## Change Order

Project:  
20-15092 WILCO ANNEX - GC  
151 WILCO WAY  
GEORGETOWN, TX

Change Order: 13  
Date: 7/11/2018  
Architect's Project:

## Change order #13

3 HIGH CEILING PLAN - COURTROOM JP201 ASI 11  
12'-0" x 12'-0"

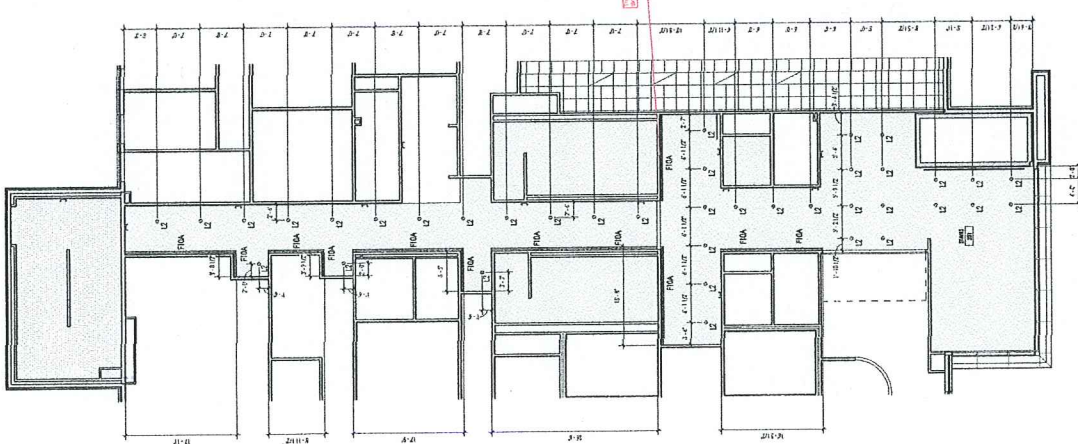
Pricing per ASI 11 to add qty 1 type F20 Finelite fixture in Entry/Stair 101 and qty 1 type Altman ME4 spot light fixture in Courtroom JP201 installed in the cloud to light up the County Seal

DATE: April 2, 2018  
NAME: Bill Bambrick  
COMPANY: Chasco Constructors  
RE: Williamson County Annex  
Description: Pricing per ASI 11 to add qty1 type F20 Finelite fixture in Entry/Stair 101 and qty1 type Altman ME4 spot light fixture in Courtroom JP201 installed in the cloud to light up the County Seal. See Notes:

NOTE:  
REPLACE FIXTURE F10 WITH F108 COURTRUM AS SHOWN.  
F108 - HP-W5-4-XX-S-835-MVOLT-SC-WB-SA-XX-XX-SF-NIGHT

2 UPPER CEILING PLAN - COURTROOM JP201  
1/4" = 1'-0"

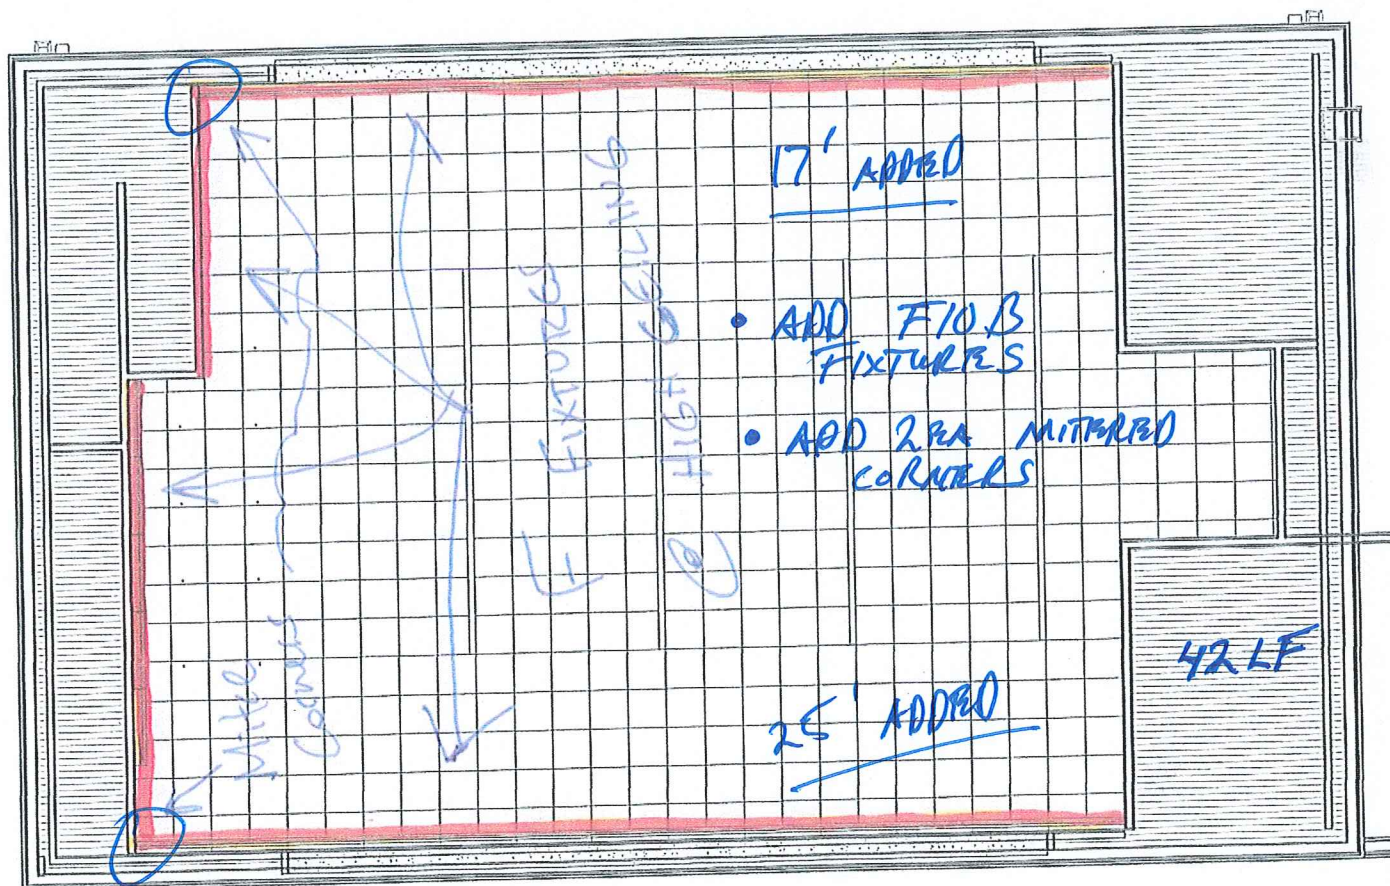
We are pleased to offer the following specifications and pricing to make the following changes:  
Pricing per Architect's preferred layout of the F-type fixtures in the high ceiling of the Courtroom JP201

WE APPRECIATE YOUR INQUIRY OF _____ AND TAKE PLEASURE IN QUOTING AS FOLLOWS						
QUANTITY	DESCRIPTION OF MATERIAL AND/OR PART NUMBER	CASH DISCOUNT	F.O.B	UNIT PRICE	UM	TOTAL
1	LOT FINELITE CHANGE - ASI 11			4,721.00	e	4721.00
	CONSISTING OF:					
	DELETED QTY 2 F10A					
	ADDED QTY 2 F10B					
Page Total						4,721.00
						4,721.00

**Model 500**

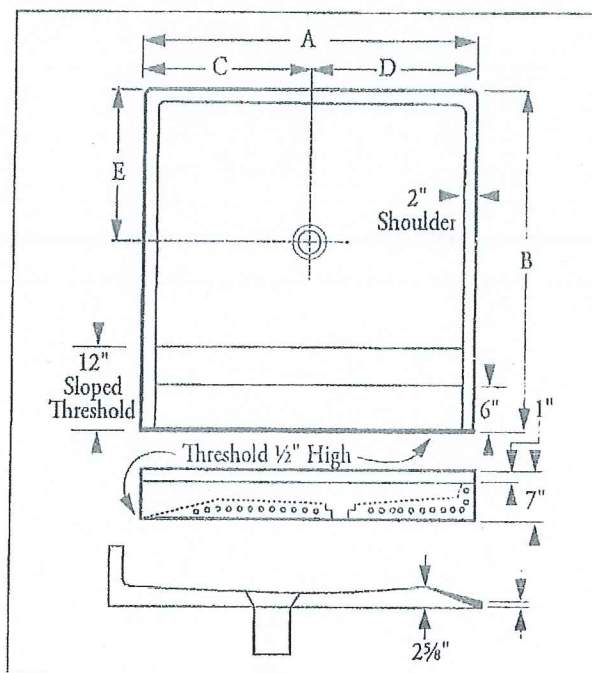
- 1 Regarding the ADA Shower Stalls. Plans conflict with Spec and there are no clear details/cross sections, regarding what you want for the shower pans and adjacent walls, including the ADA bench. Please provide all requisite information and details, including model numbers.

- 1 Reference attached cut sheets for the Terrazzo Shower Pan and ADA Shower Seat.
- Shower Seat Equal to Bobrick Model B-5181
- Terrazzo Shower Pan Equal to Florestone Model 500 Barrier-Free Terrazzo Shower Receptor - 36" x 36"
- Plumbing Fixture SHH to remain as Specified.

PLEASE REVIEW THE INFORMATION REFLECTED THEREBY AND FURNISH INFORMATION RELATED TO:  
**Door #122**

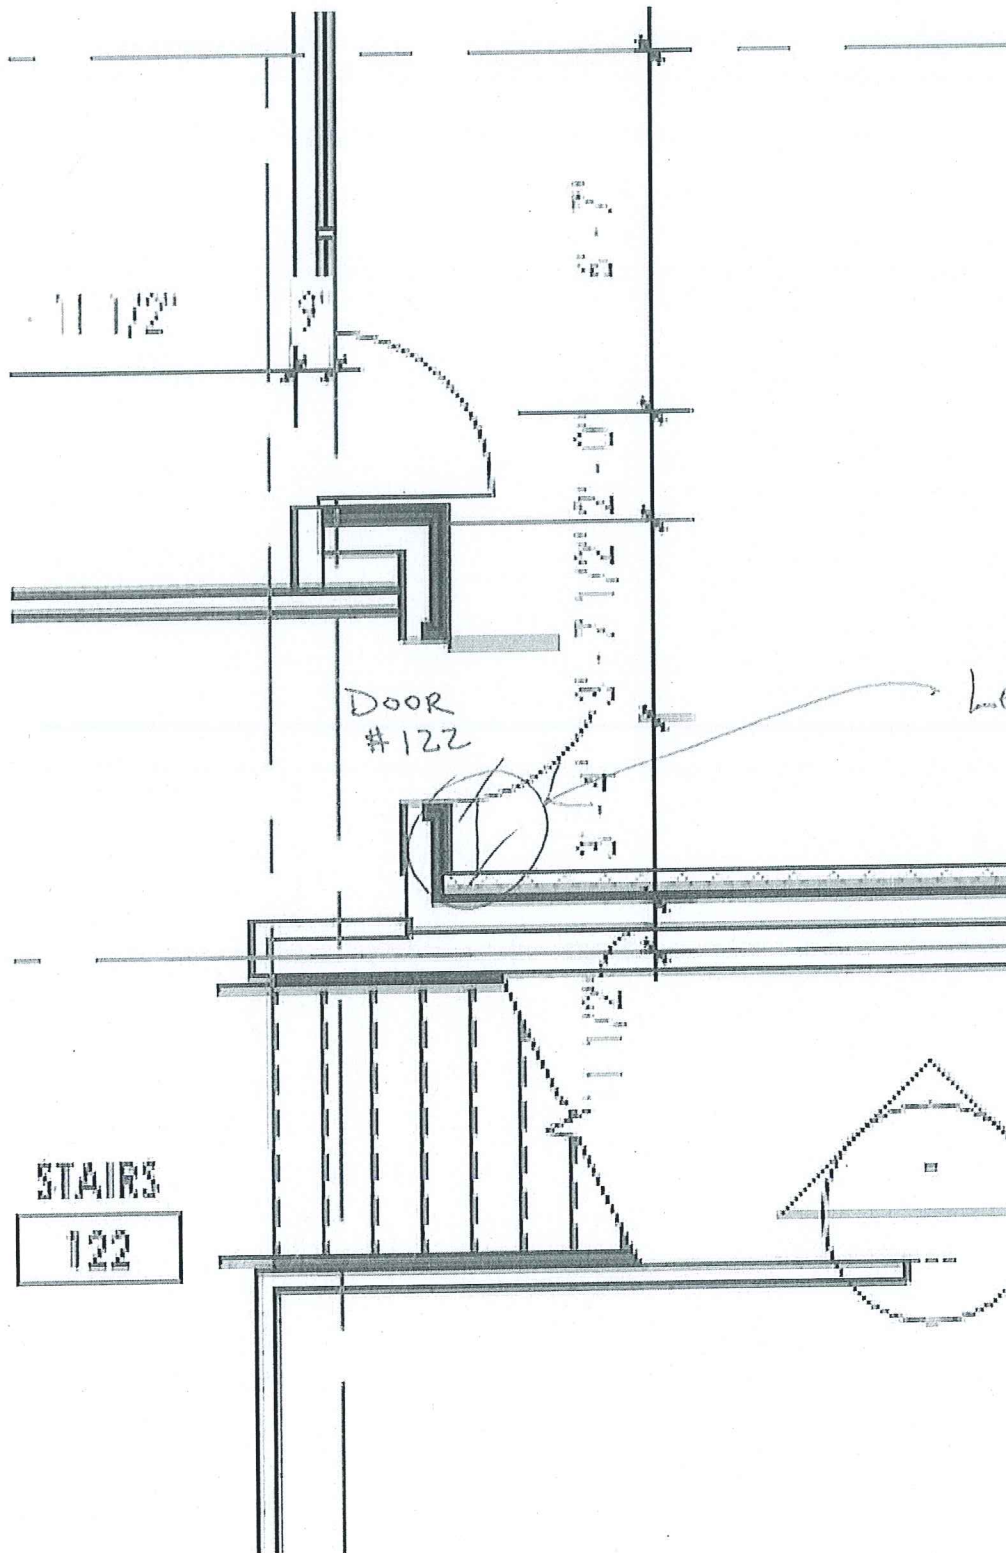
1. Please confirm the LH swing, as per the plans. There will not be the requisite 18" clearance on the exterior strike side of the door. The hollow metal frame is already on site, but can be field modified to make it an RH swing.

Yes. Door must be a RH swing to accommodate ADA. Please make the requested door swing change.
